"AS NOT BUILT" AUG. 1978

CITY OF RIVERSIDE, CALIFORNIA
DEPARTMENT OF PUBLIC WORKS

MADISON STREET
STORM DRAIN NO. 1
MAGNOLIA AVENUE
TO
POTOMAC STREET

PROJECT NO. 46
D - 240
SHEET 1 OF 1
FILE NO.

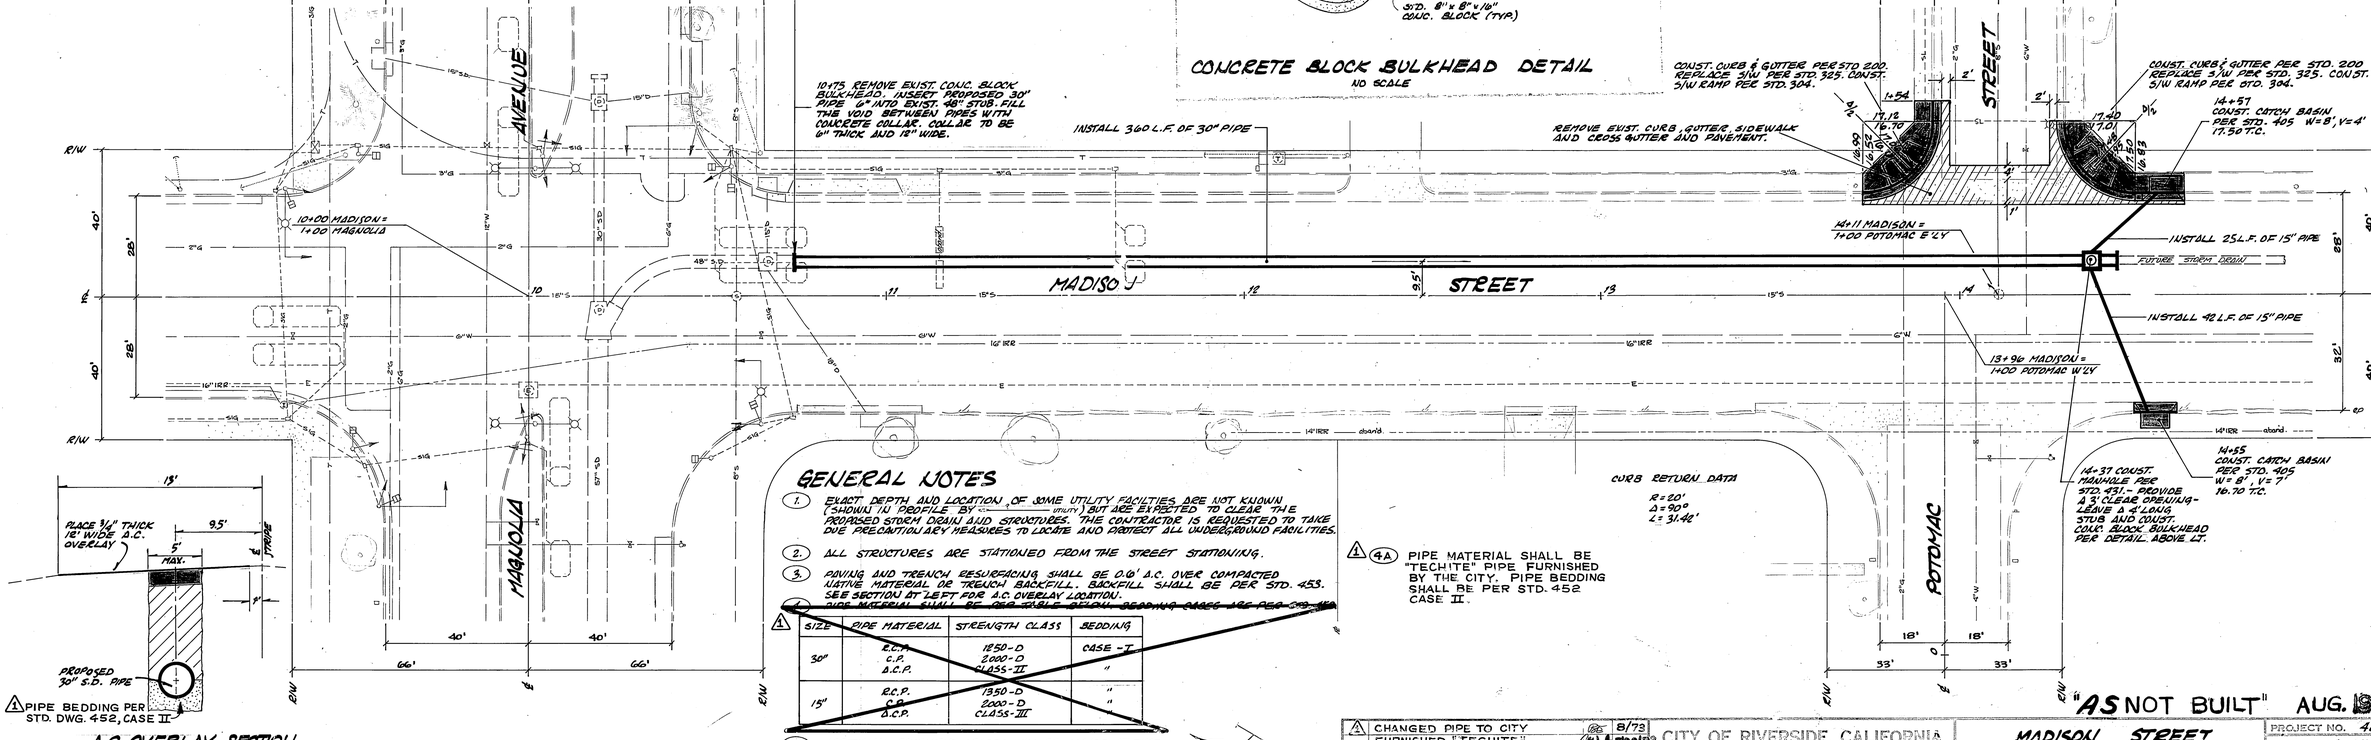
1. EXACT DEPTH AND LOCATION OF SOME UTILITY FACILITIES ARE NOT KNOWN. (SHOWN IN PROFILE BY <-- UTILITY -->) BUT ARE EXPECTED TO CLEAR THE PROPOSED STORM DRAIN AND STRUCTURES. THE CONTRACTOR IS REQUESTED TO TAKE DUE PRECAUTIONARY MEASURES TO LOCATE AND PROTECT ALL UNDERGROUND FACILITIES.
2. ALL STRUCTURES ARE STATIONED FROM THE STREET STATIONING.
3. PAVING AND TRENCH RESURFACING SHALL BE 0.6' A.C. OVER COMPACTED NATIVE MATERIAL OR TRENCH BACKFILL. BACKFILL SHALL BE PER STD. 453. SEE SECTION AT LEFT FOR A.C. OVERLAY LOCATION.
4. ~~PIPE MATERIAL SHALL BE PER TABLE BELOW. BEDDING CLASS ARE PER STD. 452~~

1 CHANGED PIPE TO CITY FURNISHED "TECHITE"	REC. 8/78	CITY OF RIVERSIDE, CALIFORNIA DEPARTMENT OF PUBLIC WORKS	MADISON STREET STORM DRAIN NO. 1 MAGNOLIA AVENUE TO POTOMAC STREET
		APPROVED BY ... DATE ... APPROVED ...	PROJECT NO. 46
		PRINCIPAL ENGINEER ... DIRECTOR OF PUBLIC WORKS	D - 240
MARK REVISIONS	BY DATE	TRAFFIC DIVISION	SHEET 1 OF 1
DESIGNED ... CHECKED ...		HYDR. GR. ... STA. ...	HOR. SCALE 1" = 20' VERT. SCALE 1" = 4' FILE NO.

4A PIPE MATERIAL SHALL BE "TECHITE" PIPE FURNISHED BY THE CITY. PIPE BEDDING SHALL BE PER STD. 452 CASE II.

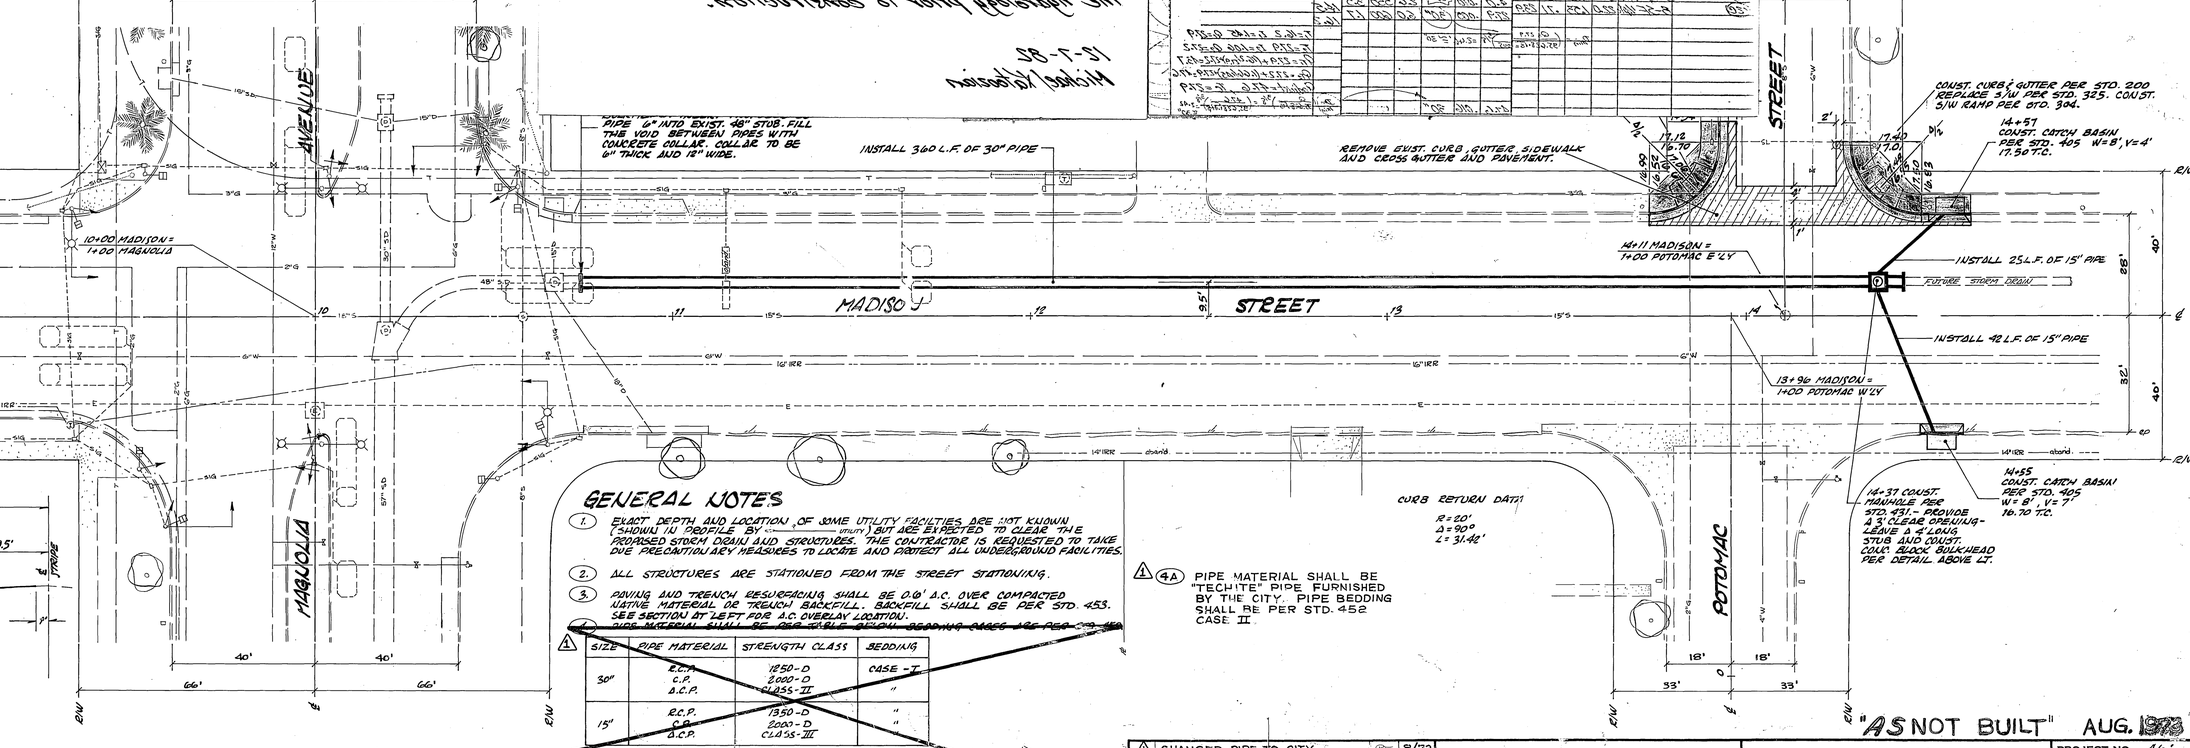
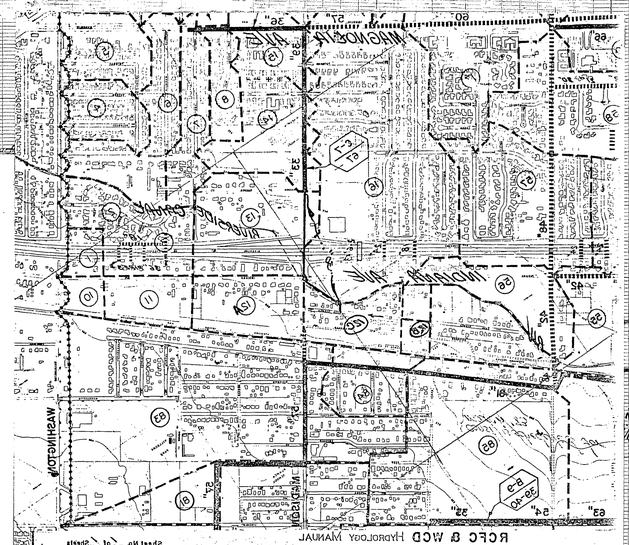
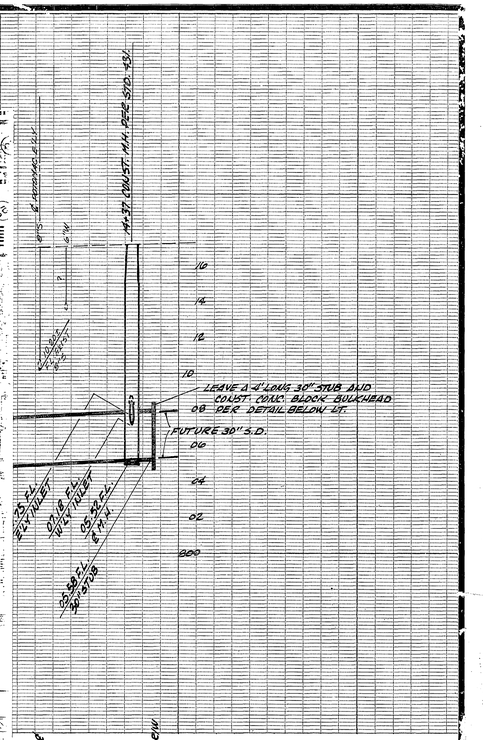
Note to the future designer,

This storm drain (D-240, 1of1), due to unavailability of funds, was not constructed in 1973.

In December 1981, as the study for the Abandonment of Riverside Canal was being done, it was noted that the 30" pipe would be replaced in early the generated's plan for sub-area ⑩, ⑪, ⑫, ⑬, ⑭ (see heading). It could be removed and 1+V 30" pipe is needed upstream of Madison + Indian, and that a bigger size pipe would be needed downstream of Magnolia. Magnolia. It appears that the recent estimate of 39" pipe is a more realistic assessment of the amended design than the 24" pipe as indicated on this drawing.

The plans be signed is used to receive the hydrology prior to construction.
